From: HUTCHINS MICHAEL [REDACTED]
Sent: 04 March 2013 16:47
To: Janice Chapman
Subject: Re: BR/129/11 - Replacement first floor bay to front elevation and installation of additional second floor bay to match, Langford House, 7 The Steyne, Bognor Regis

In response to your subsequent e-mail of 4th March in respect of the above planning approval BR/129/11 the approved drawings show a flat roof.

Proposed east elevation (front)

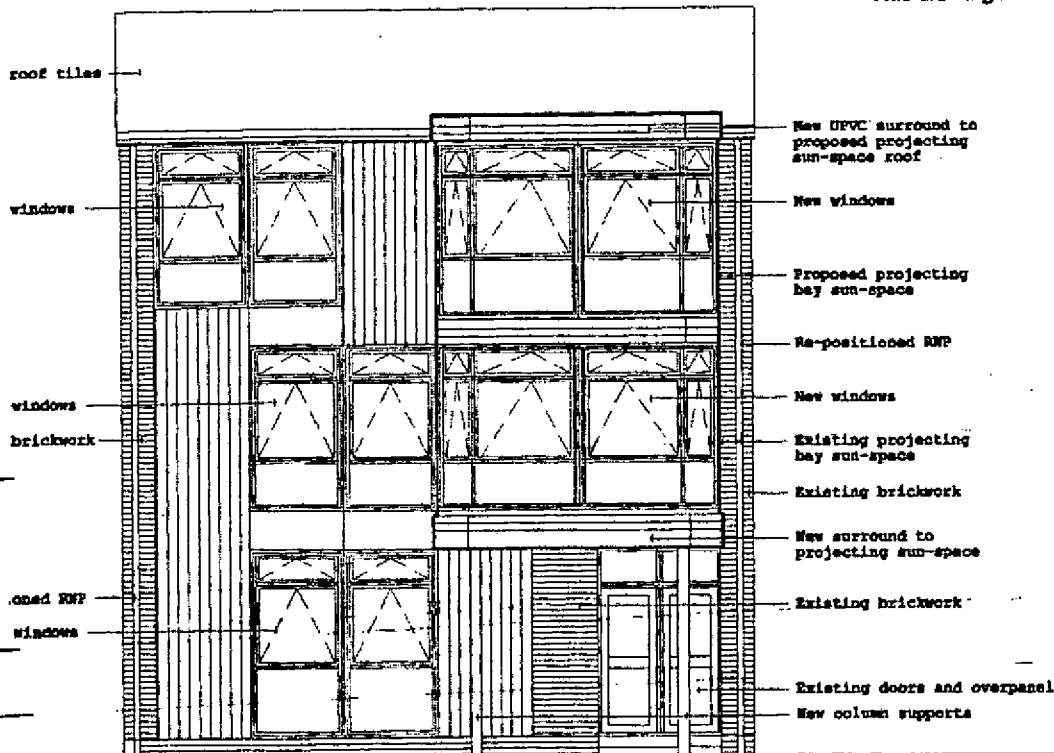
1. Does the Planning Permission allow for cutting into the existing roof line? If so, by how much? (Obviously this affects the overall look of the roof line in the Conservation Area of The Steyne.)
2. Do I need Planning Permission to change the existing wooden soffits & fascias to white UPVC?
3. Do I need Planning Permission to change the existing grey rainwater down pipe from the side of the building to a white pipe on the front?

In response to your subsequent e-mail of 4th March in respect of the above planning approval BR/129/11 the approved drawings show a flat roof.

Amazon Windows

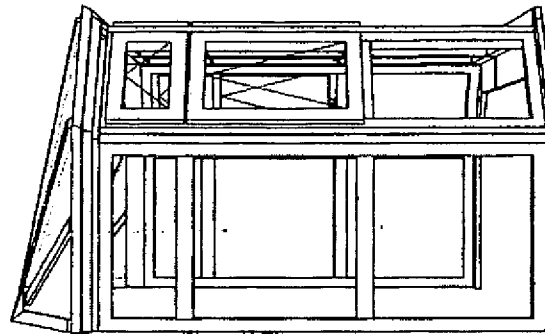
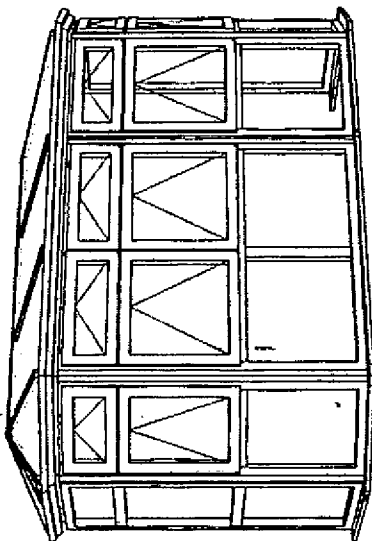
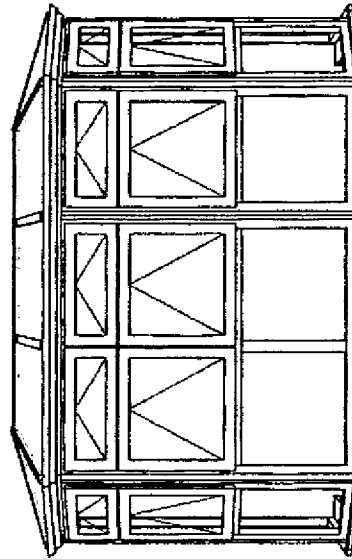
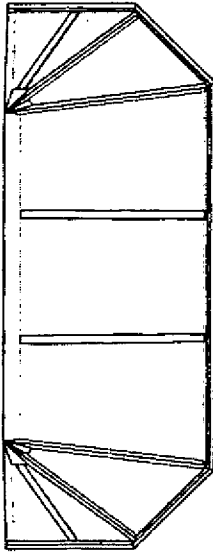
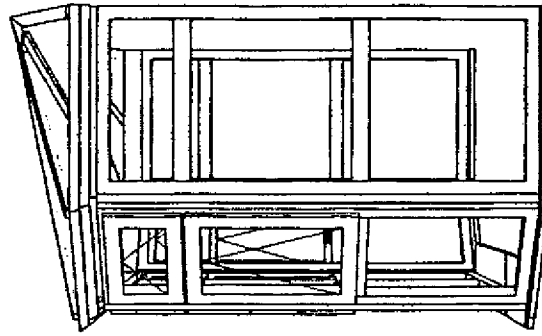
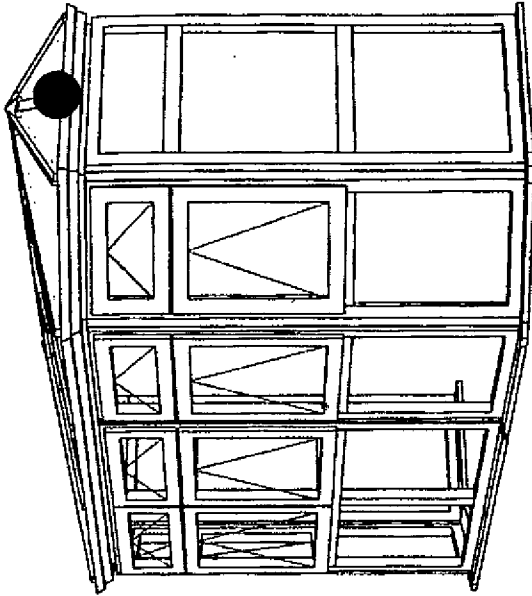
Also, in your recent reply (3rd paragraph), you mention that 'the revision to the roof detail would be acceptable'. **Can you confirm that you are referring to the Churchill Interior Finishing Ltd drawing (rather than the CAD drawing with 3 windows)?** I assume that you are happy with this because the roof is at a lower level than on the agreed Planning Permission drawings.

I have viewed the submitted drawings and the revision to the roof detail would be acceptable. However, the drawing of the bay window and elevations do not accord. The existing windows have two panels of glazing to the front which has been approved and the drawing has three panels of glazing. This would be totally out of keeping with the existing design of the windows on the host building and would require the submission of a new planning application. I have spoken to the Conservation Officer, Mr White who informs me that to preserve and enhance the Steyne Conservation Area we are requesting that any wooden windows be replaced like for like in details and materials. If an application were to be received for the three panel windows then it would be likely to be refused. It should be noted that as the property is flats then any replacement of windows in the building which should be like for like in design would require the submission of a planning application as flats have no "Permitted Development".

I attach copies of the planning permission drawing, a CAD of the proposed sun room (with sloping roof) and a drawing of the proposed steel supports which also shows how the new (sloping) roof will attach to the existing property. I am meeting Amazon windows next week to try and get their explanation of how the 3 different drawings can be reconciled and actually be built. The judge, on Tuesday, was keen for a meeting to take place with a planning officer, on site, so that all was clear and permissions were given in writing before any work takes place, and so that a build is not done which may later have to be removed. I would really like to stick to his suggestion, for complete transparency, and therefore request a time when it is convenient for you to meet with us and the company.

The Conservation Officer and myself would need to see a detailed plan with elevations showing the new sloped roof before we could advise you whether this could be treated as an amendment rather than a new application. However, any amendment would still require an application for a Non-Material Amendment.

The 3rd paragraph was referring to the Churchill Interior Finishing Limited drawing not to the CAD drawing with three windows which is not acceptable.
